**Minutes of the Town of Perinton  
Planning Board Meeting of January 7, 2015**

**Lyons National Bank – Perinton branch – northeast corner of O'Connor Road & Fairport Road intersection.** BME Associates, as agent for Lyons National Bank, contract vendee of property owned by DiPrima Properties II, LLC and located at northeast corner of O'Connor Road and Fairport Road intersection (tax id#152.11-1-36 from the resubdivision of Lots 2 and 3 of CVS Subdivision), requesting preliminary and final site plan approval for proposed development of 1.16 acre site for a new 5,176 s.f. branch for Lyons National Bank.

**Re: Lyons National Bank - Perinton**

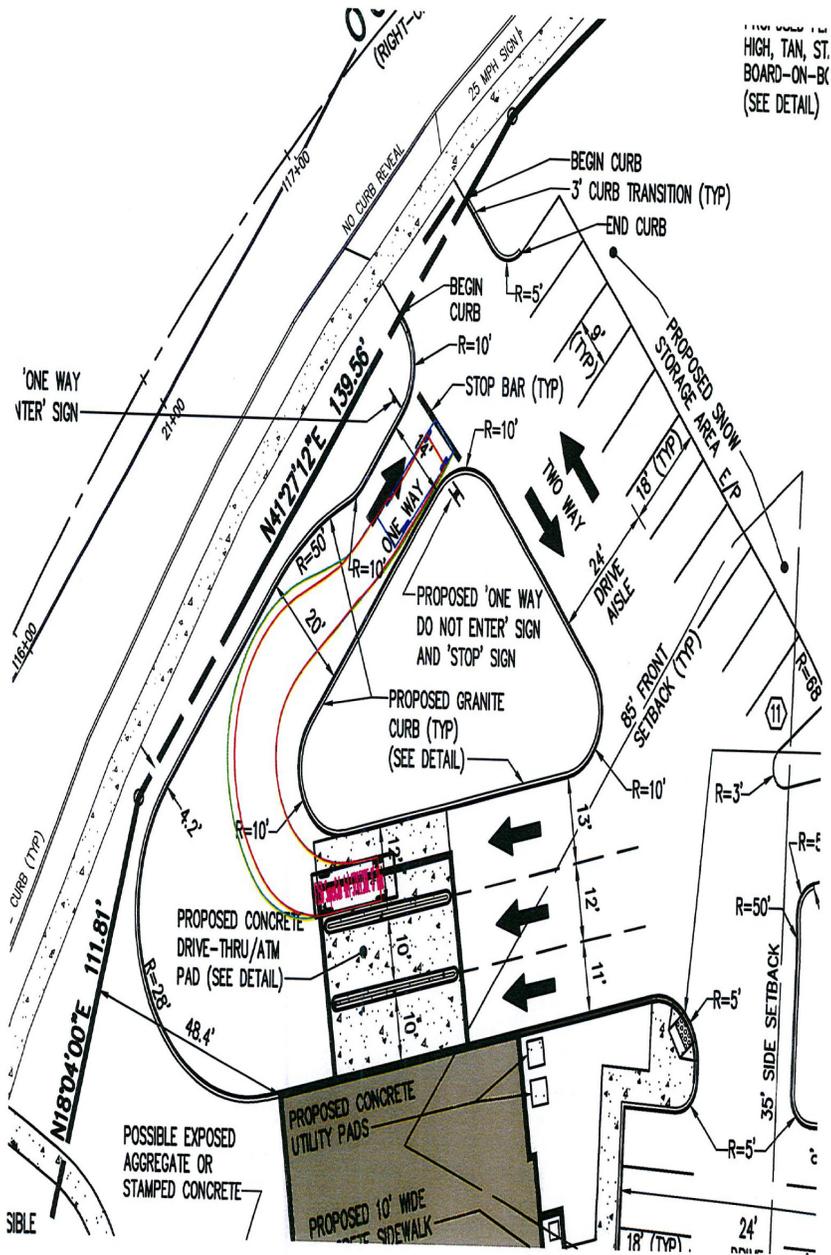
8. DPW acknowledges that impervious areas on this site will decrease by 26% and therefore water quality treatment is not required in accordance with NYSDEC guidelines. However, impervious surfaces did not previously drain directly into the wetland north of

the project site as they will after the proposed development. As such, DPW requests that the applicant consider including some type of water quality feature to treat the site runoff.

**A sketch showing a possible bio-retention area along the north side of the parking area for water quality purposes was sent to the Perinton DPW and Conservation Board for review on December 30, 2014.**

Lyons National Bank-Perinton 01-05-15 1"=30'  
 (F150 SuperCab 4x4 with 8' Bed)

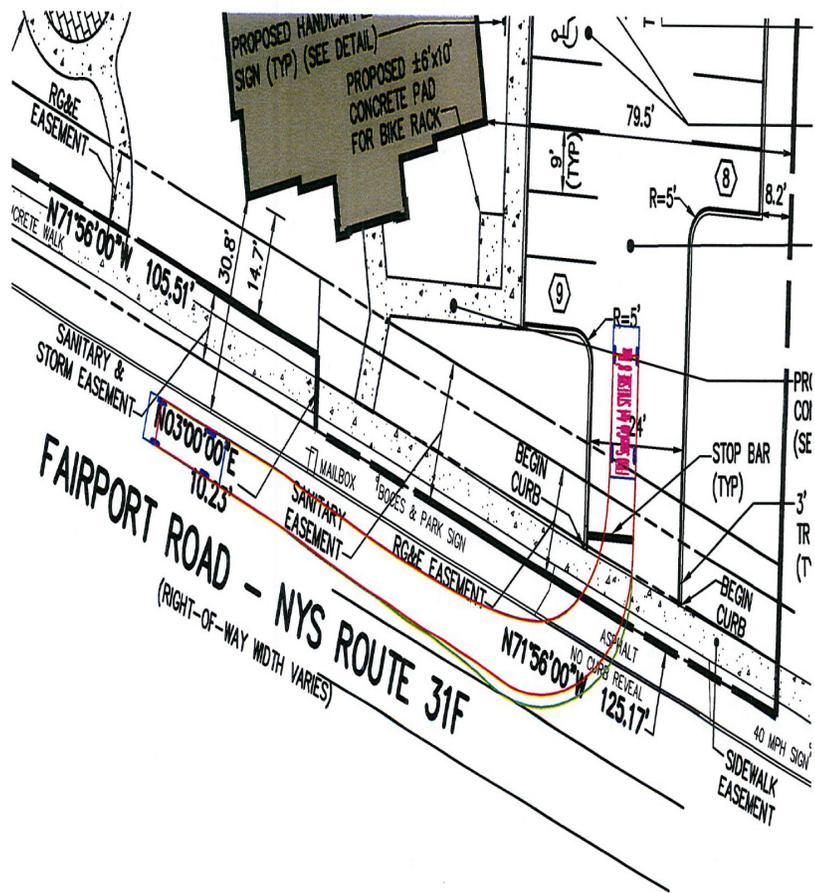
9. Confirm that a larger passenger vehicle (e.g. pickup truck or SUV) can make the turn around the 10' radius curbed island from the inside ATM lane.

**Attached is a design turning template sketch showing that a Ford F150 SuperCab 4x4 truck with an 8' bed can maneuver around the proposed 10' radius curbed island.**
